Office of the City Manager

PUBLIC HEARING
June 4, 2024

Subject: ZAB Appeal: 2113-15 Kittredge Street, Use Permit #ZP2022-0144

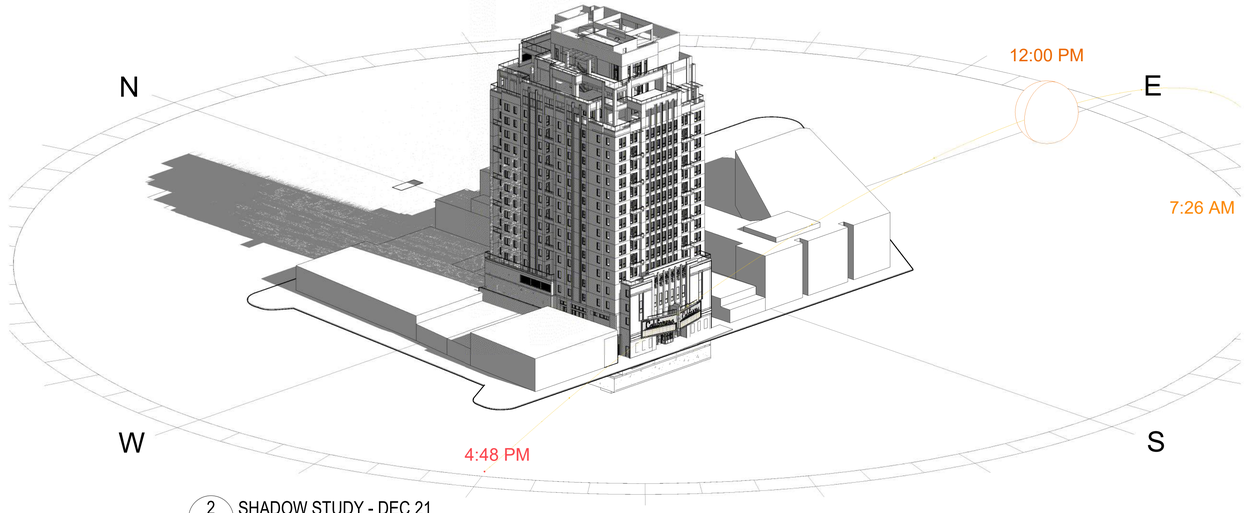
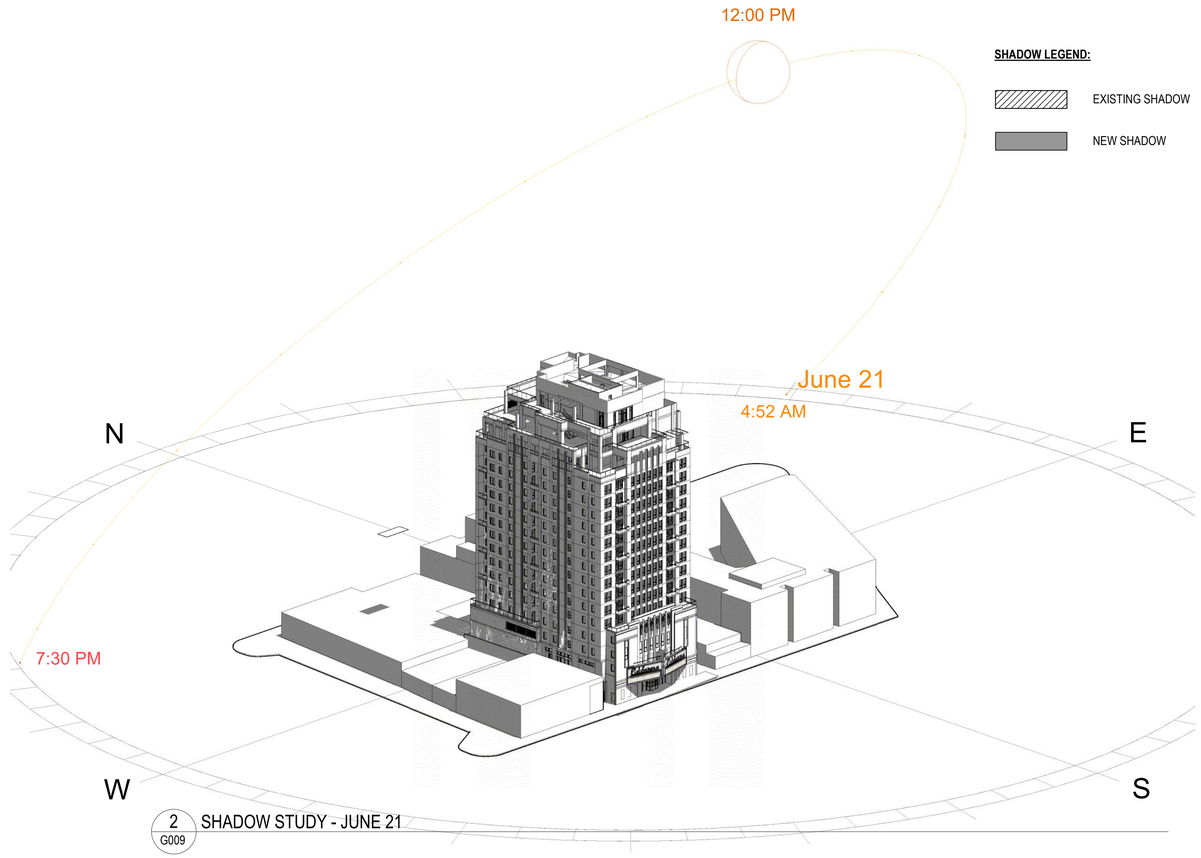
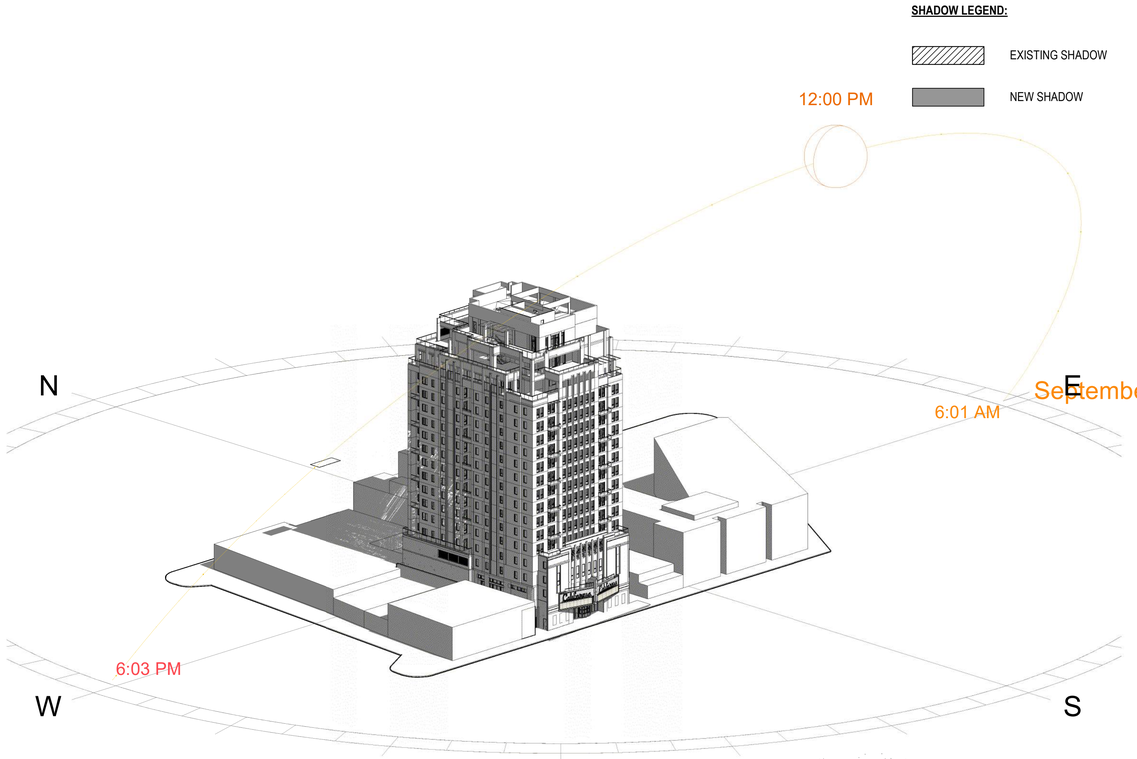
Shadows: According to the shadow studies submitted for the project (See Attachment 2, Project Plans – Sheets G008 through G010). New shadow impacts would occur 1) in the summer months and fall months around noon and in the hours before sunset on the mixed-use residential building at 2134 Allston Way to the north and the mixed-use residential buildings at 2220-40 Oxford and 2165-77 Kittredge Streets to the east; and 2) in the winter months in the hours before sunset on the mixed-use residential buildings at 2161 Allston Way and 2173-75 Allston Way to the northeast. All other new shadows would impact commercial buildings in the vicinity. The extent of the new shadow impact from the project on the site's adjacent areas would not be unreasonable for a development in the dense, downtown district that allows building heights up to 60-foot, with zero to five-foot setbacks from property lines, by right.

Source, Google Earth, April 2022

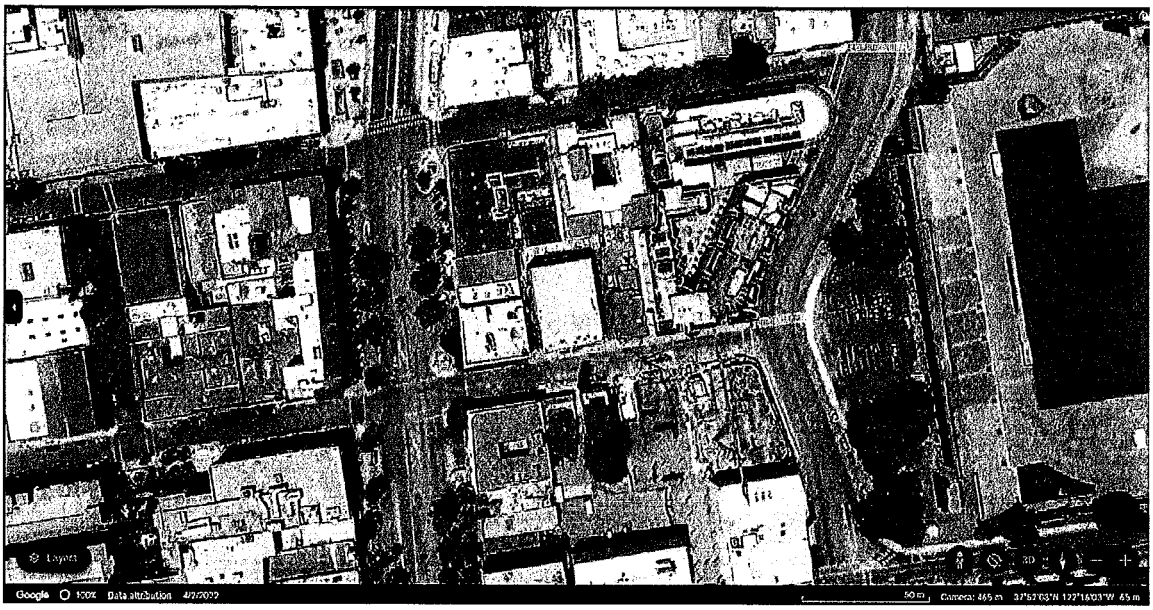
Review of Google Earth demonstrates that there are existing sensitve receptors at residential developments adjacent to the Project site (see screenshot below).
